SIGAR Inspection – 13-1

KUNDUZ ANA GARRISON: ARMY CORPS OF ENGINEERS RELEASED DYNCORP OF ALL CONTRACTUAL OBLIGATIONS DESPITE POOR PERFORMANCE AND STRUCTURAL FAILURES

OCTOBER
2012

Figure 1 - Kunduz PRT March 2012 with Elevated Building Pad and Positive Drainage System

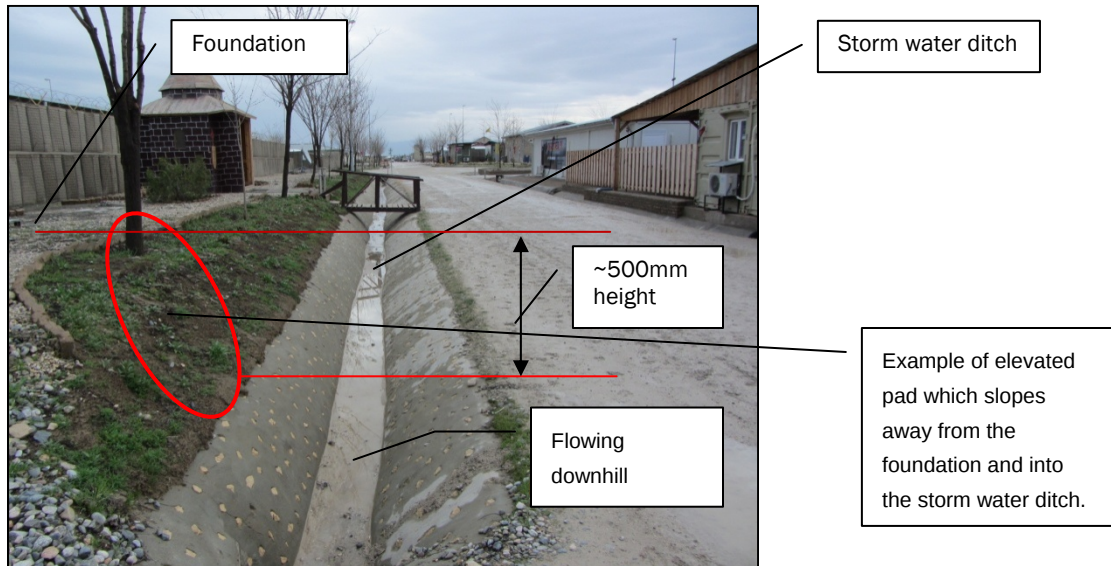
Figure 1 illustrates a typical drainage channel and elevated building pad at the Kunduz PRT.

Figure 2 - SIGAR Analysis of Historical Sink Holes and Structural Failures

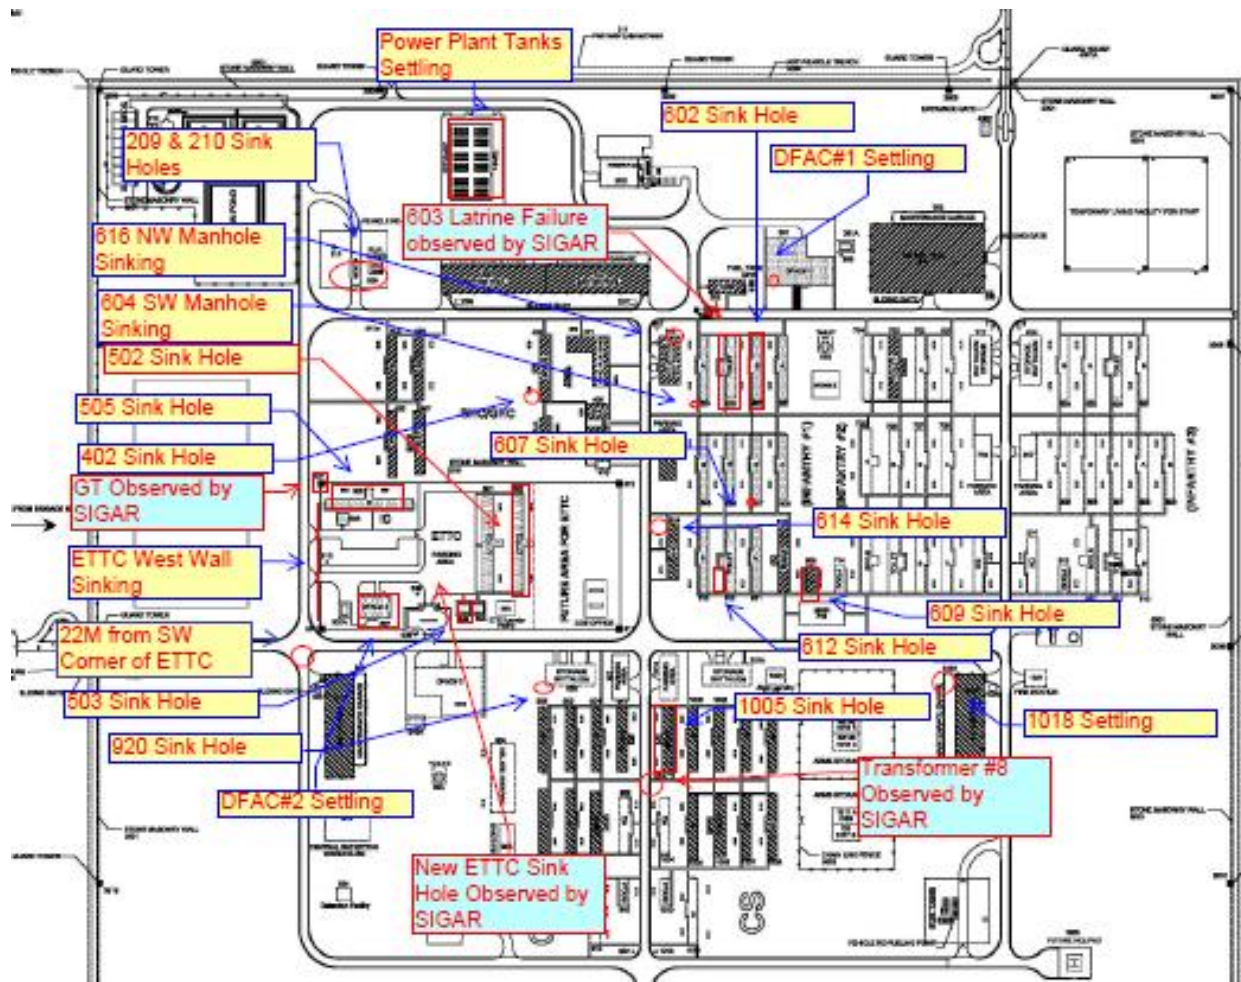
Soil instability continues to cause sink holes and structural failures at Camp Pamir, as can be seen in figure 2. Based on our review of data provided by USACE-TAN, we have noted sink holes and structural failures over a 2-year period, highlighted in yellow. We also noted our observations from the site visit on March 25, 2012, highlighted in blue. These included new sink holes occurring at various locations, including the ETTC. During the site visit, we also observed structural failures at transformer 8 and building 603 (latrine), and noted that building 604 (barracks) was visibly beginning to settle.

Figure 10 - Standing Water on Road Indicating that Water is Not Draining into Storm Water Ditches as Designed

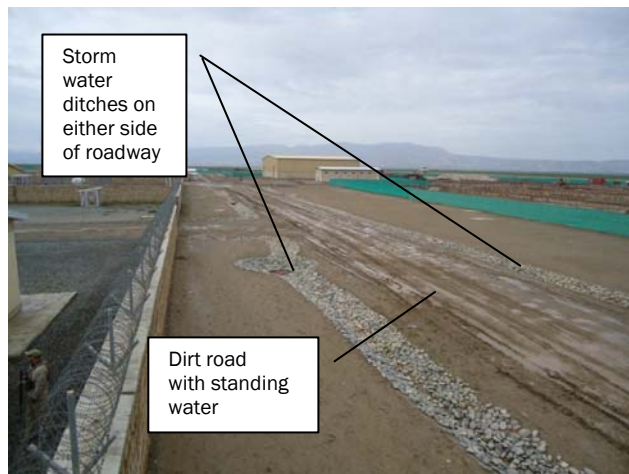
appropriate road grading, water accumulated on the road surfaces and drainage channel, indicating improper drainage. Figure 10 illustrates standing water on one of the road surfaces.

²⁴ In response to this report, USACE-TAN indicated that it is addressing the road grading issue under contract W5J9JE-11-C-0076, Biltek, Garrison Expansion (phase III).

USACE/TAN is addressing the road grading issue at Camp Pamir under contract W5J9JE-11-C-0076, Biltek, Garrison Expansion (Phase III). The contractor will construct asphalt paving over the existing unpaved ring road, cross streets within the ring road, and roads leading to the primary and secondary entry control points; all within the existing garrison compound and as indicated in the Conceptual Site Plan. The paving system will be designed to carry 40 metric ton five-axle vehicles and will include a storm drainage system. The contractor will also provide a graded, compacted, crushed aggregate access road around the entire exterior perimeter of the existing garrison and sufficient drainage ditches to receive expected runoff from the road and will grade the road surface to direct water runoff to these ditches. Finally, the contractor will provide culverts where required to ensure proper drainage outward from the garrison.
